**Re: Contract No. HY/2010/08
Central – Wan Chai Bypass – Tunnel (Slip Road 8 Section)
Additional Mitigation Plan for Slip Road 8 (Rev. 7)**

Additional Mitigation Plan for Slip Road 8 (Revision 7) under FEP-10/364/2009/B for Contract No. HY/2010/08

**Central – Wan Chai Bypass Tunnel
(Slip Road Section 8)
Contract No. HY/2010/08**

Additional Mitigation Plan for Slip Road 8 under condition 2.16 of FEP- 10/364/2009/B

TITLE:
LAYOUT PLAN FOR ADDITIONAL WALKWAY
BEHIND REPROVISIONED BGO

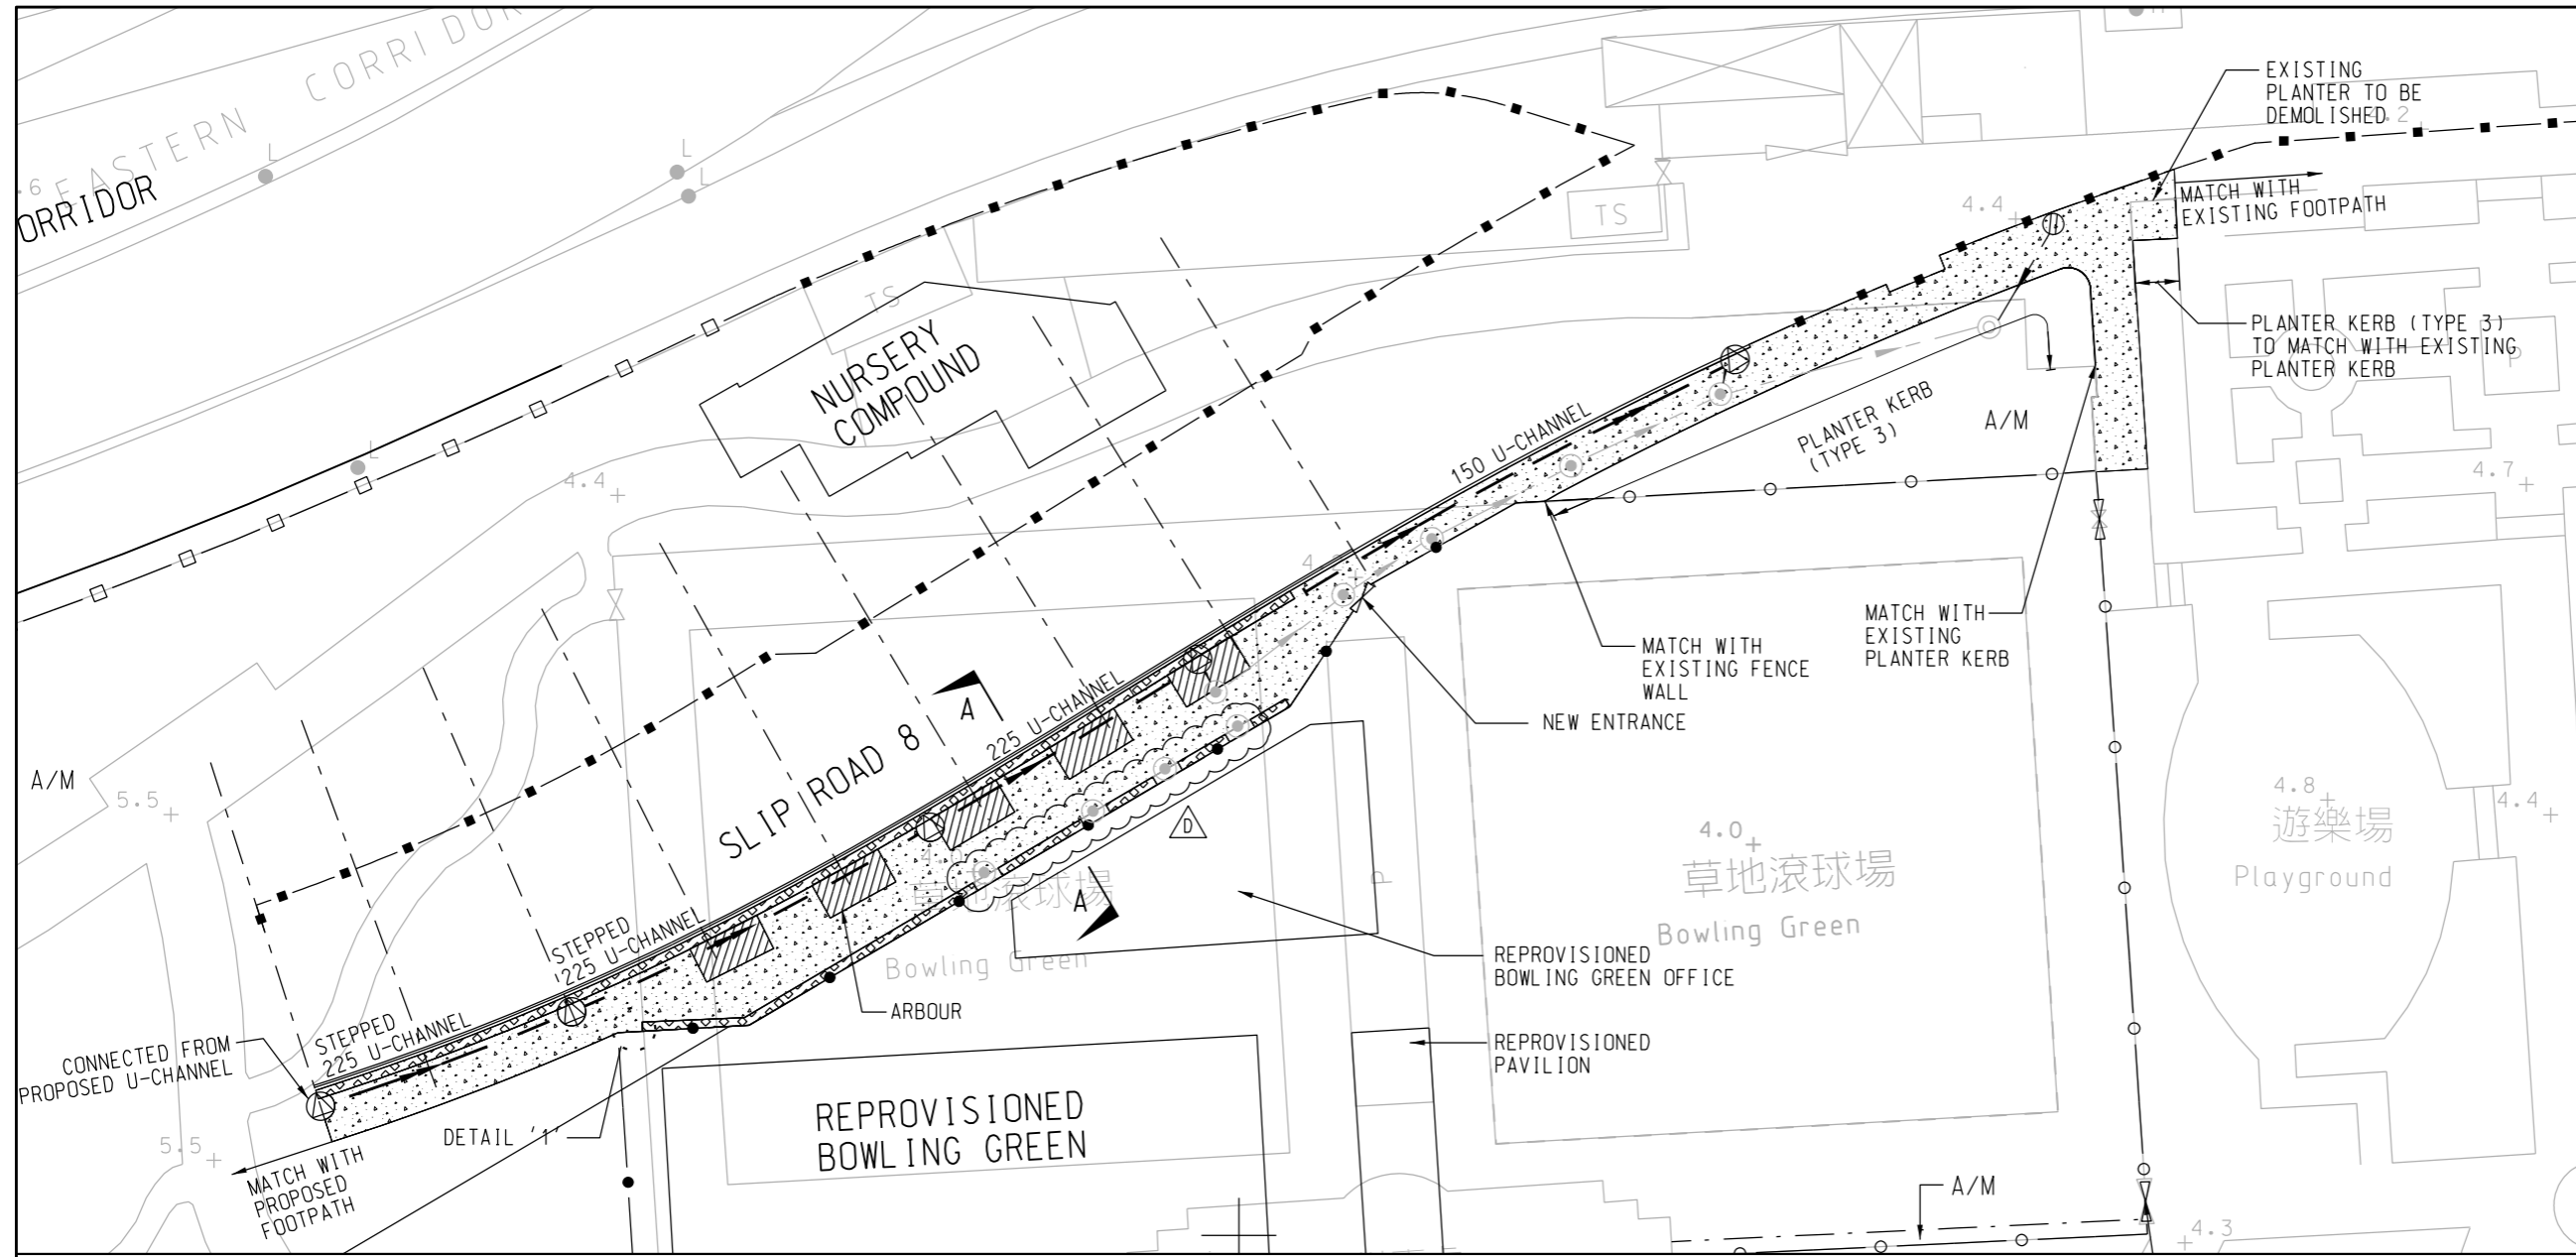
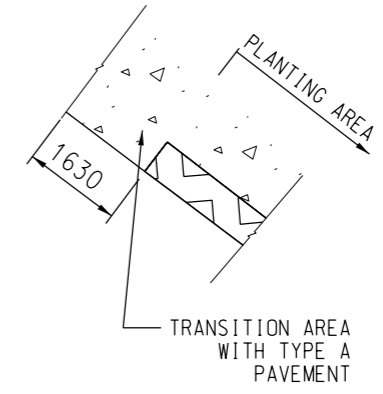
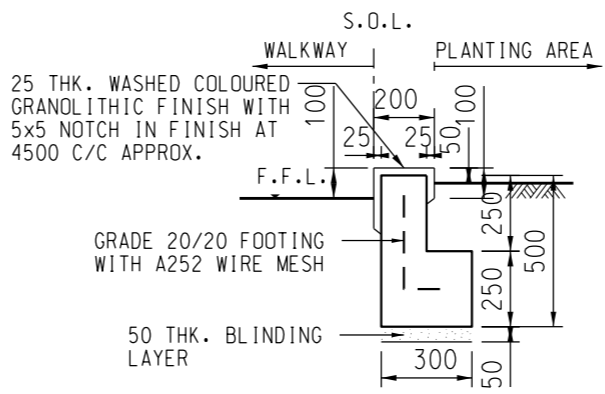
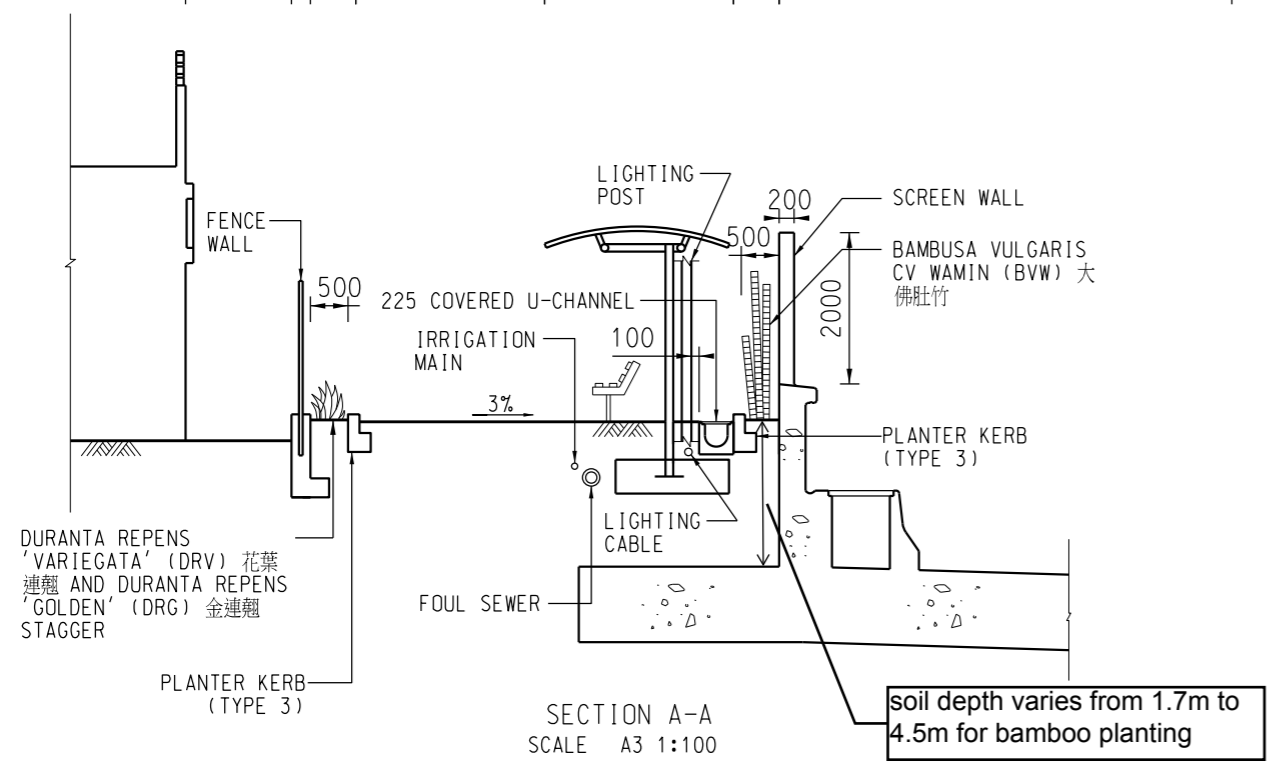
Replacement of Shrub Planting with Bamboo Planting at the Additional Walkway

I refer to the joint site inspection on 15 October 2019 amongst D. C. Member Dr. Jennifer Chow, representatives from VPMO, CSHK and AECOM/RSS, concerning the replacement of shrub planting [*Duranta repens* 'golden' (DRG) 金連翹] with bamboo planting [*Bambusa vulgaris* cv Wamin (BVW) 大佛肚竹] at the Additional Walkway as shown in the attached Sketch No. 60095653/T2/SK0750A.

It was recorded that both Dr. Chow and VPMO had no adverse comment to the replacement planting. As previously agreed, the completion date of the Establishment Period for the concerned planting remains at 29 January 2020.

TITLE:
 PLANTING PLAN FOR ADDITIONAL WALKWAY
 BEHIND REPROVISIONED BGO

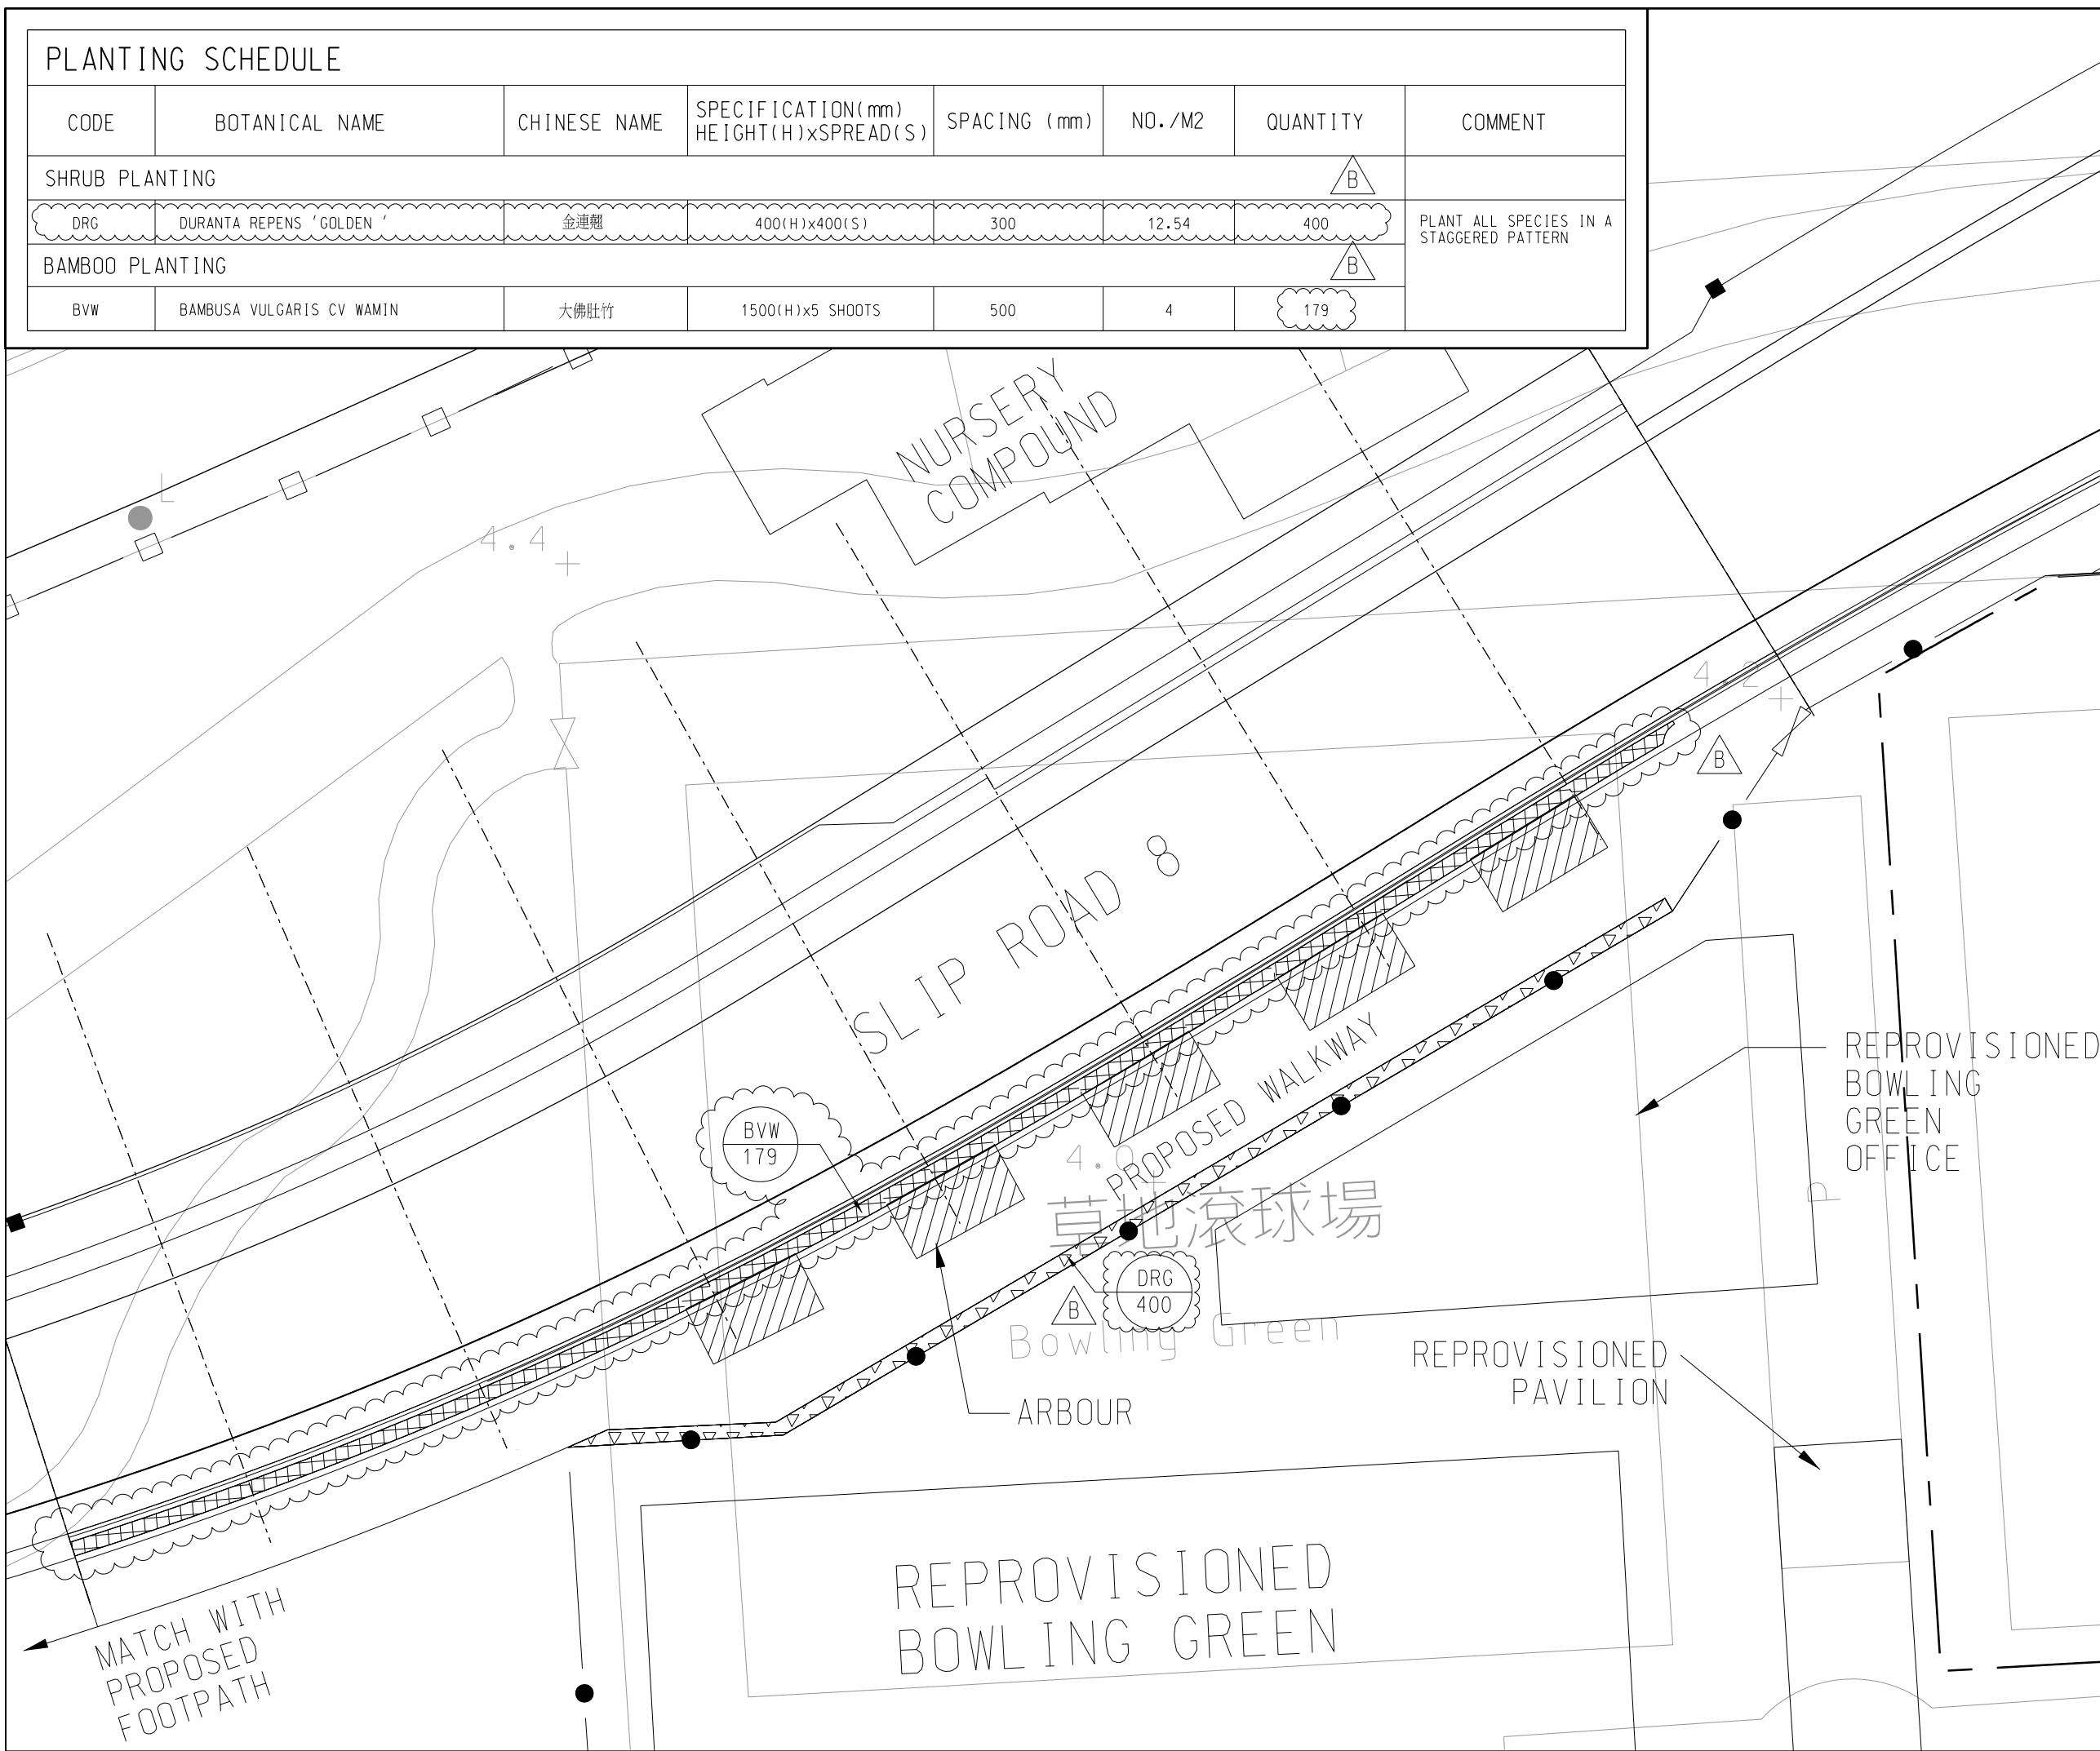
As discussed in the VPMO Meeting yesterday, please advise whether you have any comment on the proposed planting plan for the additional walkway as shown on the attached Sketch No. SK0750.

Please be advised that we have no adverse comment for the proposed planting plan for the additional walkway and the proposed location of 12 nos. transplanting trees.

Deletion of Wall Pattern on Screen Wall

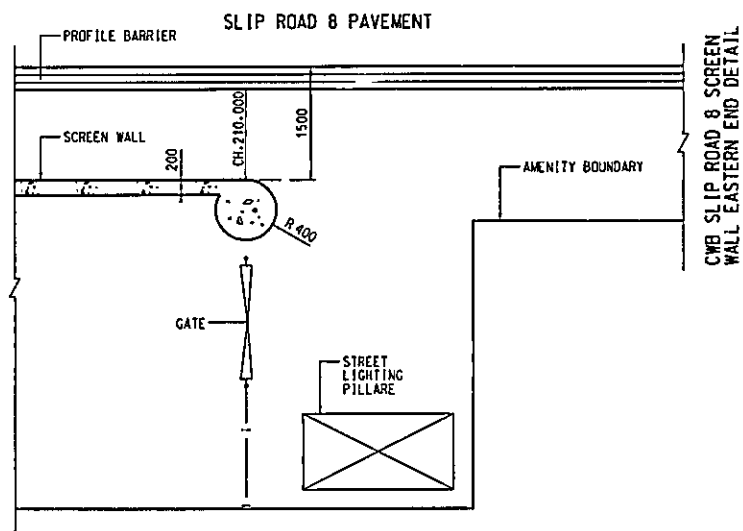
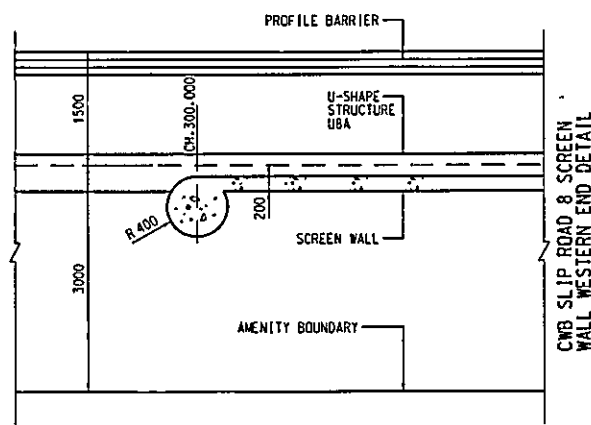
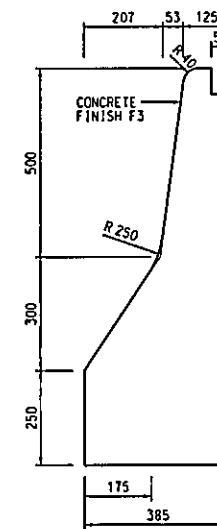
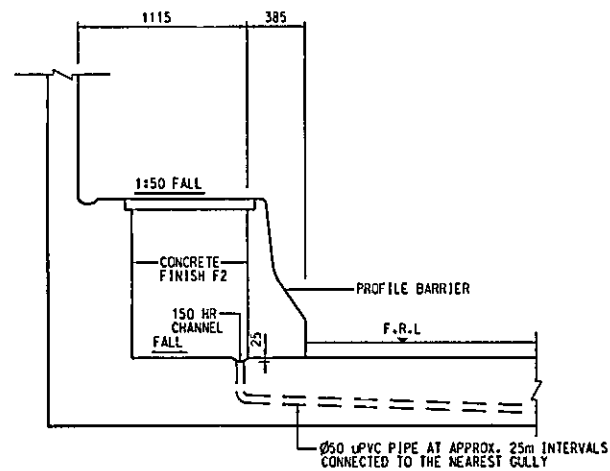
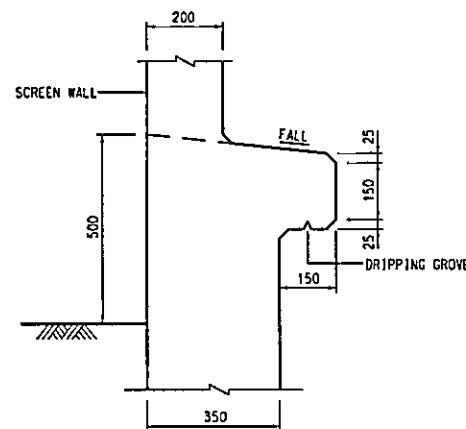
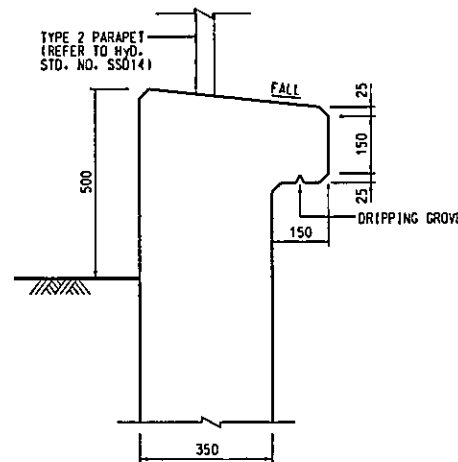
In accordance with GCC Clause 6(3), i enclose Sketch No. 60095653/T2/SK0760 showing the deletion of the wall pattern on the Screen Wall.
